HISTORIC AND DESIGN REVIEW COMMISSION

September 18, 2019

HDRC CASE NO:	2019-456
COMMON NAME:	1211 E Commerce
ZONING:	D
CITY COUNCIL DIST.:	2
APPLICANT:	Paul Kahlich/MCS Architects, LLC
OWNER:	Raju Bhagat/Kennedy Hotel, LP
TYPE OF WORK:	Construction of a 4-story hotel
APPLICATION RECEIVED:	August 06, 2019
60-DAY REVIEW:	October 05, 2019
CASE MANAGER:	Edward Hall

FENESTRATION PATTERN RECOMMENDED BY STAFF

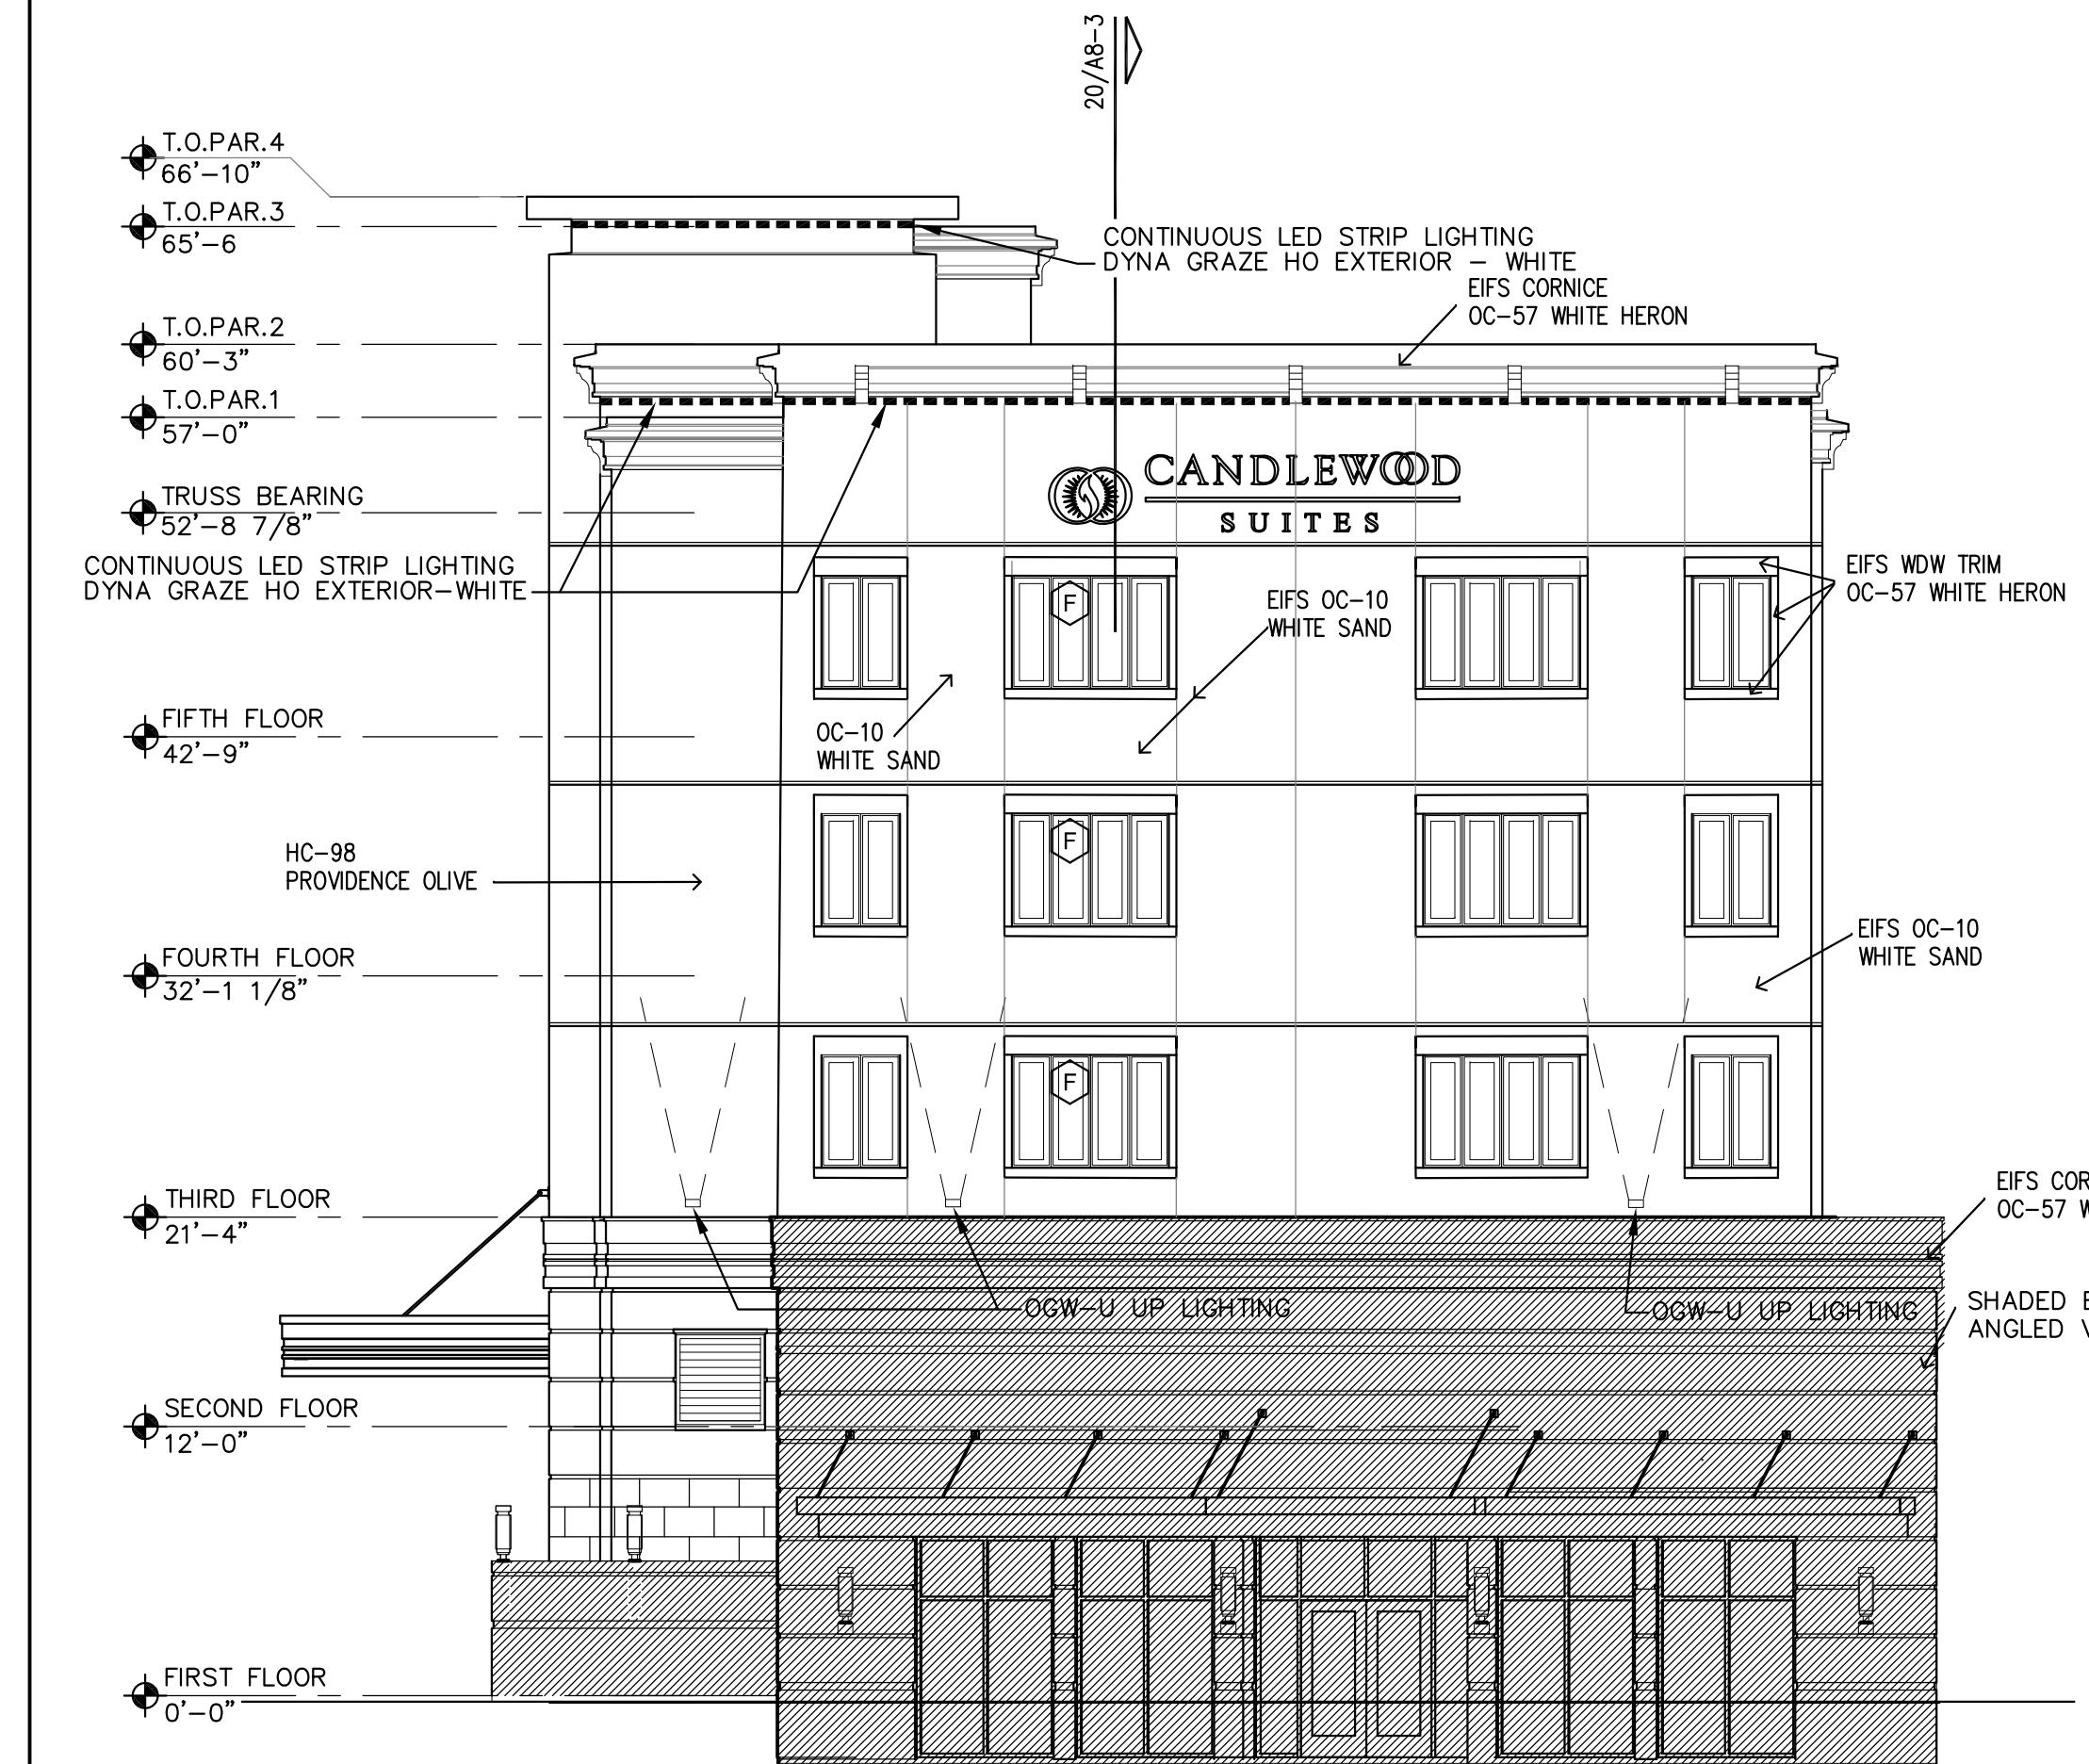
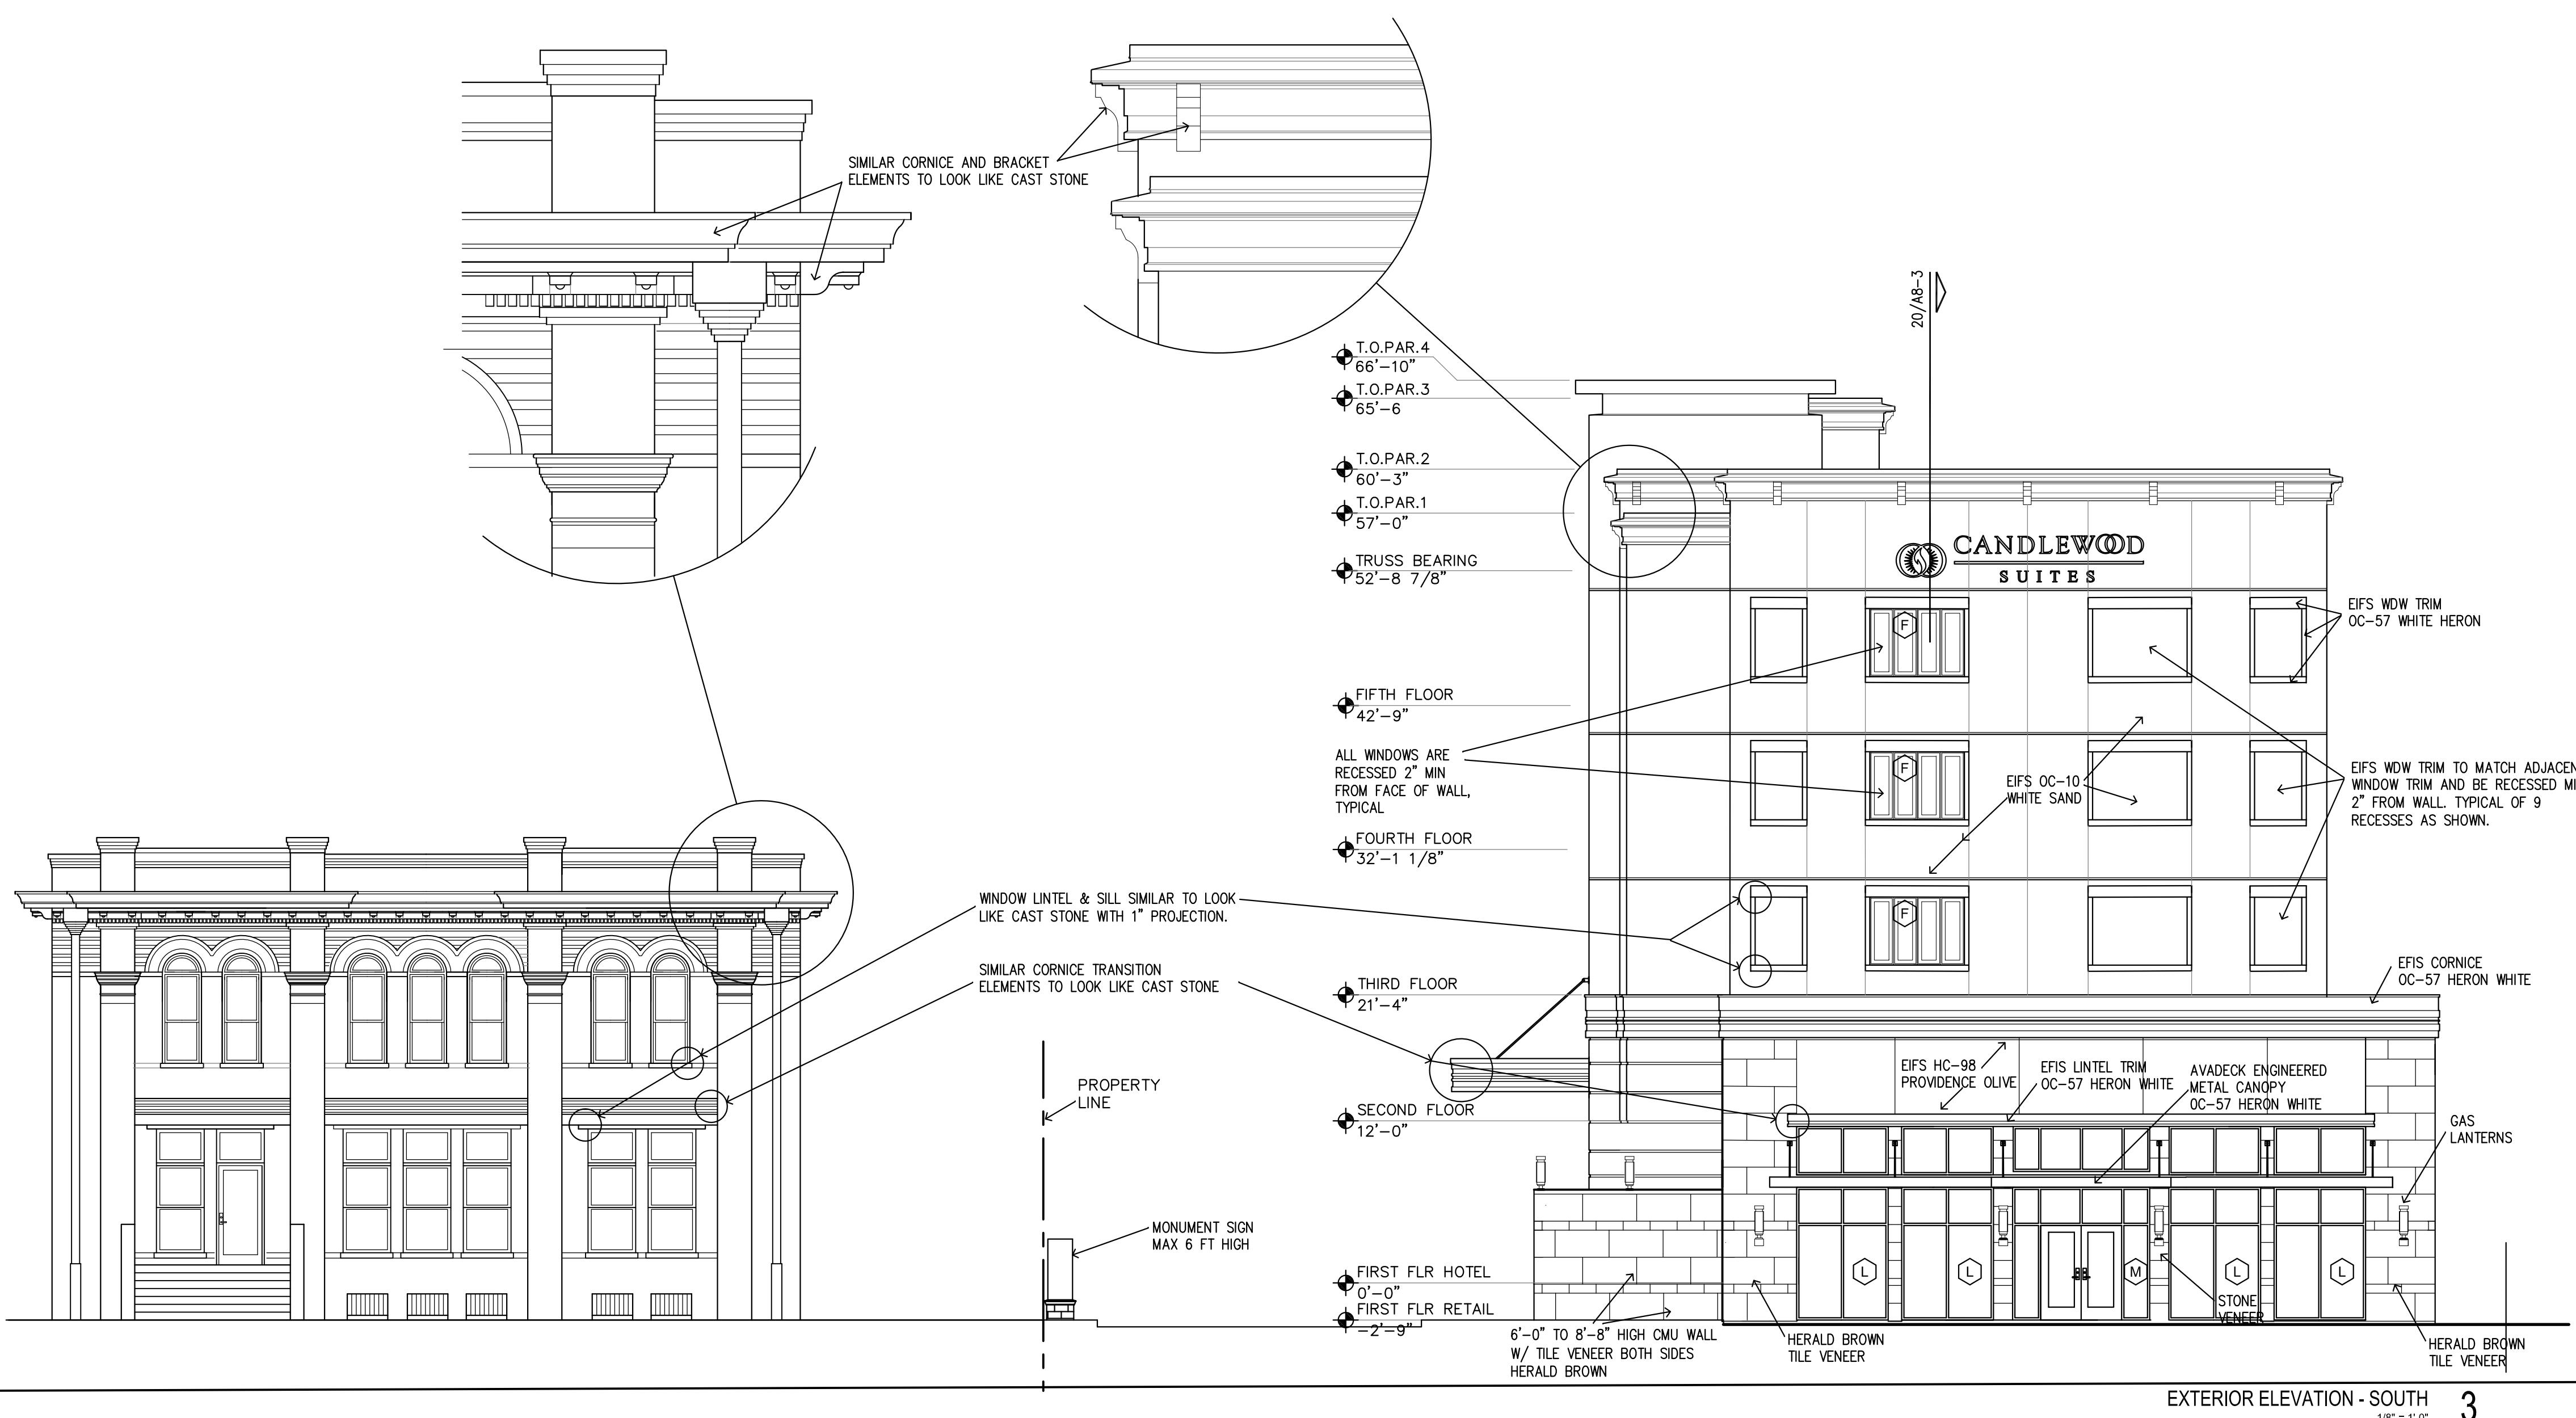
- i. FENESTRATION – The applicant has proposed additional façade separation on the south façade; however, fenestration has not been included. The applicant has proposed recessed façade panels that mimic window openings. Staff finds this to be inappropriate, and finds that actual windows that are recessed two (2) inches be installed at each location. Not only would this introduce more depth and dimension to the street façade, but it would also relate the proposed new construction to the adjacent historic structure.

- ii. That the south elevation feature windows rather than recessed façade panels as noted in finding i. Staff has labeled the recommended elevation within the exhibit file.
